ADDENDUM #04

DATE:	September 29, 2023	PROJECT NO.:	Project # 20229080 CRSA Project # 21-031
TO:	Gramoll Construction 155 S. 750 W. North Salt Lake, UT 84054	PROJECT:	Rio Grande Depot Seismic 300 S. Rio Grande St. SLC, UT 84101

This Addendum forms a part of the Contract Documents and modifies the original Bid Documents dated October 3, 2022 as noted below. Acknowledge receipt of this Addendum in the space provided on the Bid Form. Failure to do so may subject the Bidder to disqualification.

AE507

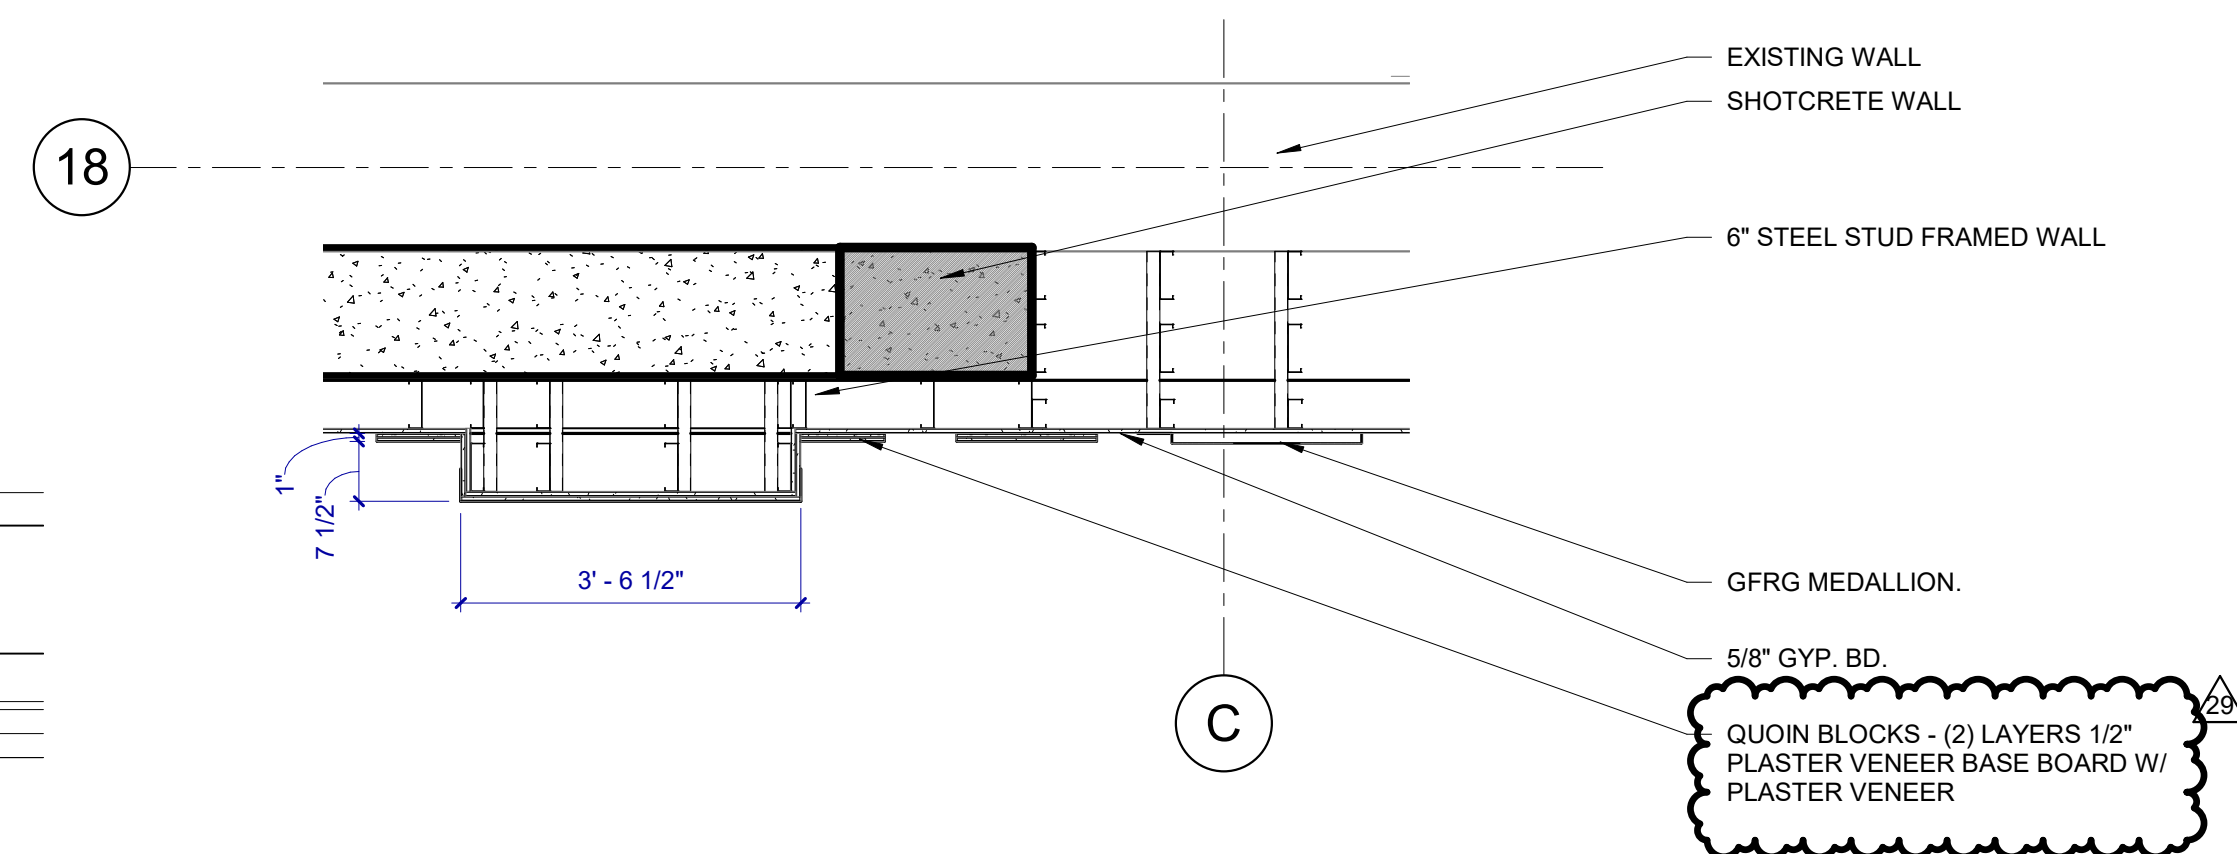
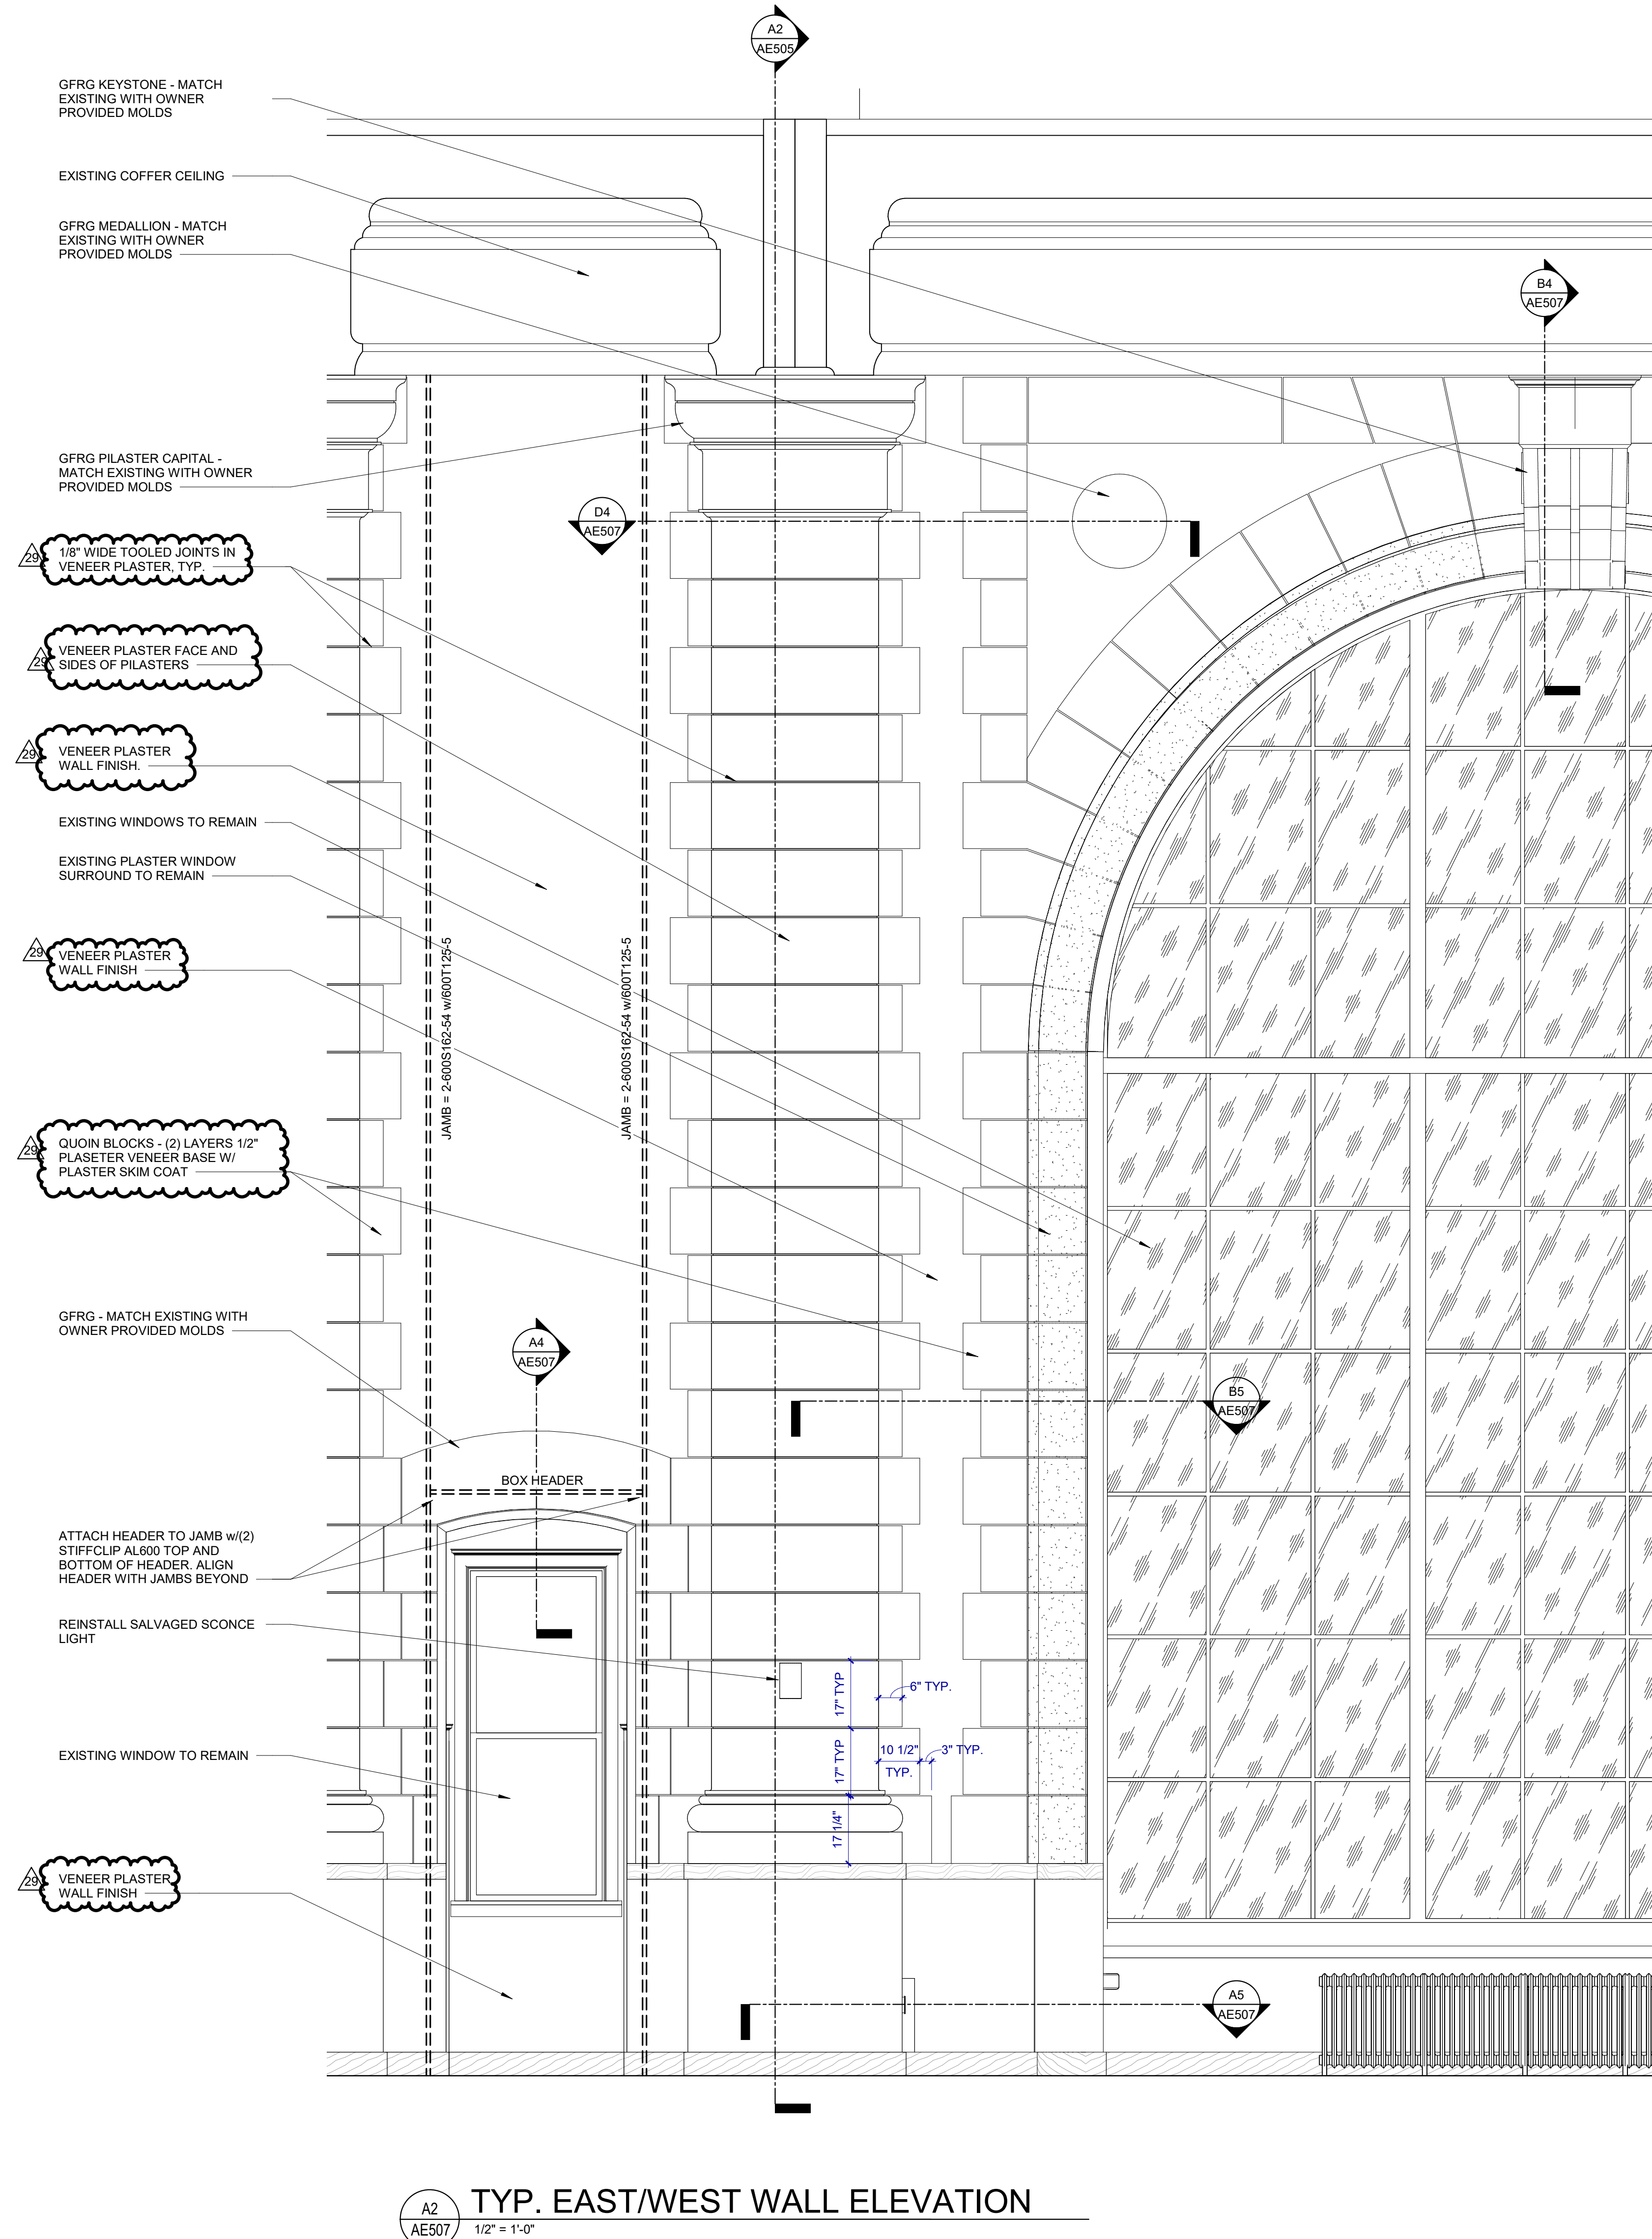
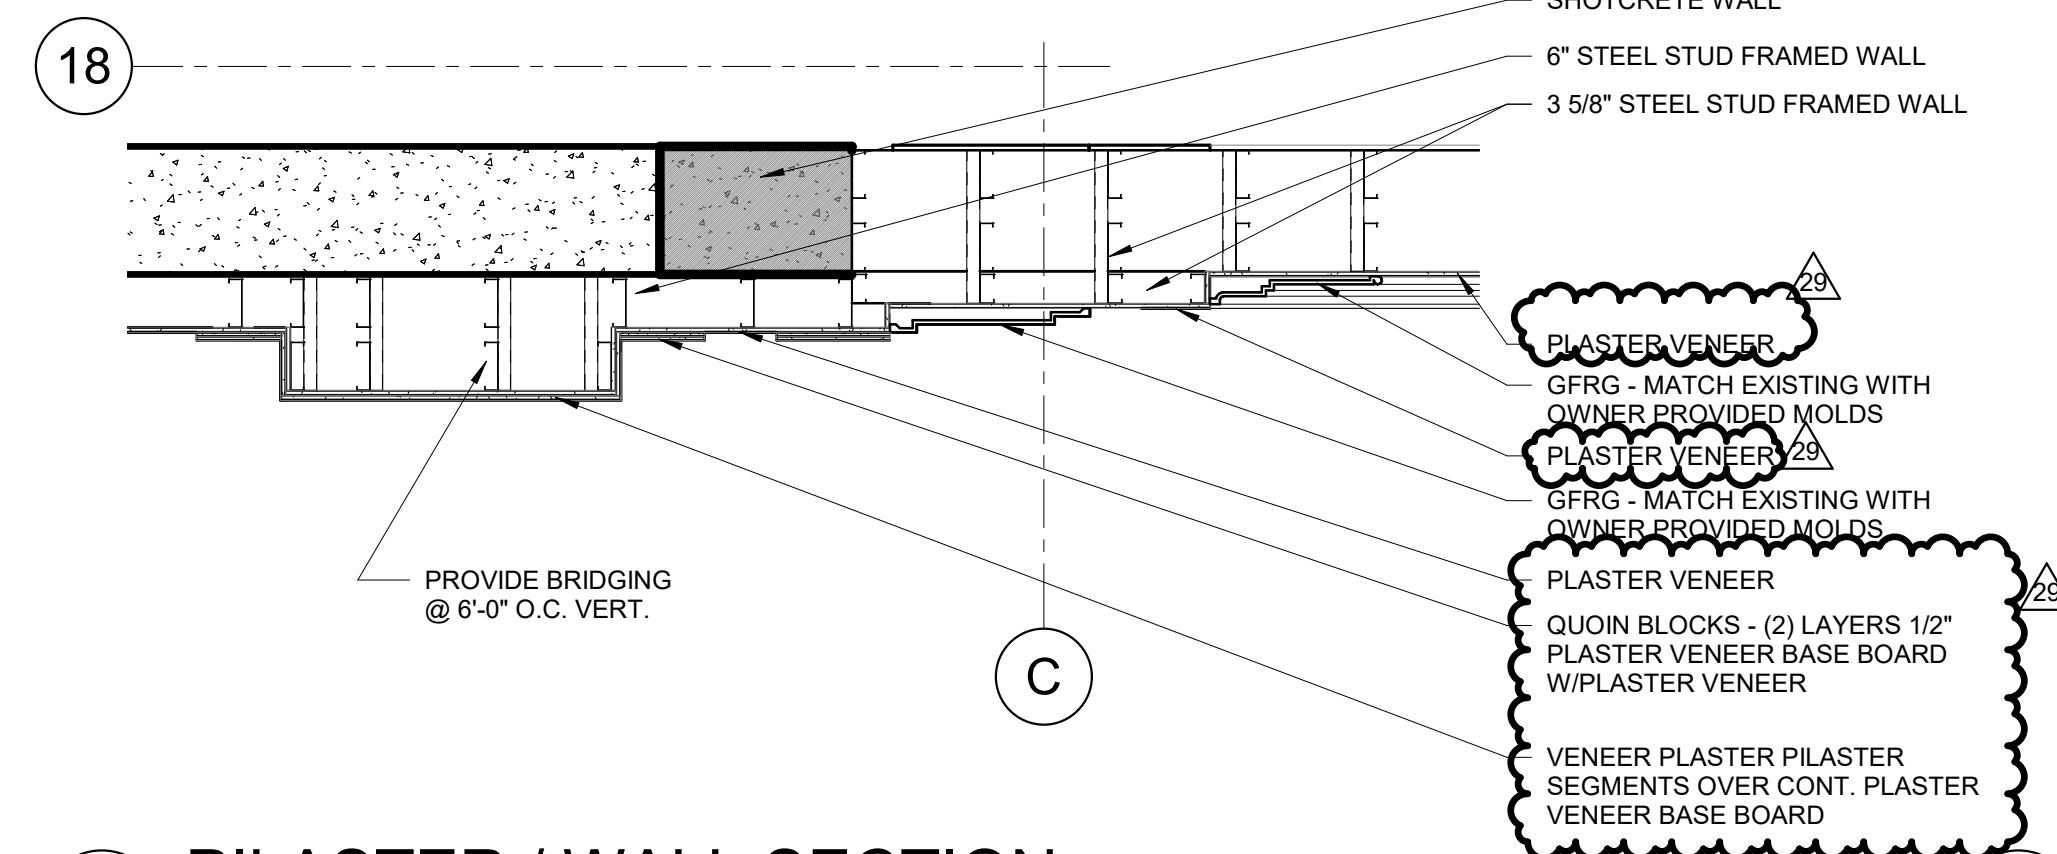
VI-8 AE507: Changed gyp board notes to veneer plaster system.
